Subject: Statement of Evidence for Proposed District Plan (PDP)

Hearing 14 - Urban Zones

Fig. 1: Bulk & HIRB. Street section to illustrate the general concept of Height in relation to Boundary (HIRB) - example for several urban zones, as viewed from street level

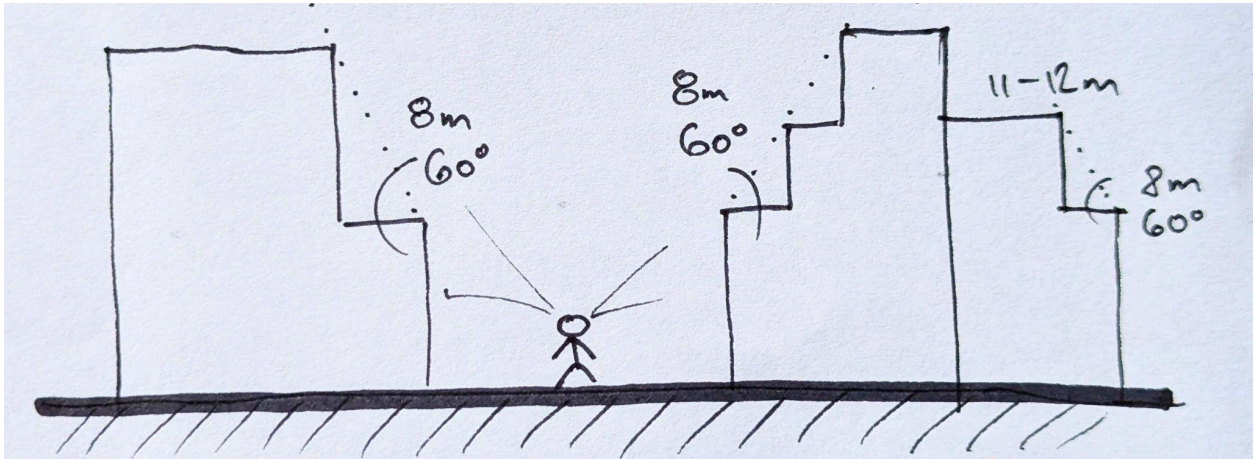
- **Maximum Height:** 12m.
- **Height in Relation to Boundary (HIRB):** No control between MUZ sites (as per PDP: MUZ-S2). However, for facades facing a public street (frontage), for example, a 60-degree recession plane at 8m above ground level should be introduced. This allows for taller buildings but requires upper levels to be set back, reducing perceived bulk at street level.
- **Setback:** 3m from residential or open space zones only (as per PDP: MUZ-S3).

- **Lower the proposed central zones along the street**
Preserve a village character at the town's core by maintaining a lower, more human-scaled built form along the ridgeline at the building frontage, defined by HIRB.
Priority level: CRITICAL

- **Frontage HIRB:** Apply HIRB to street frontage in relevant urban zones to reduce building bulk & retain a "village character"
- **Strategic use of topography:** When considering height restrictions and rezoning, apply a holistic approach that uses topography strategically in order to balance growth and character issues.
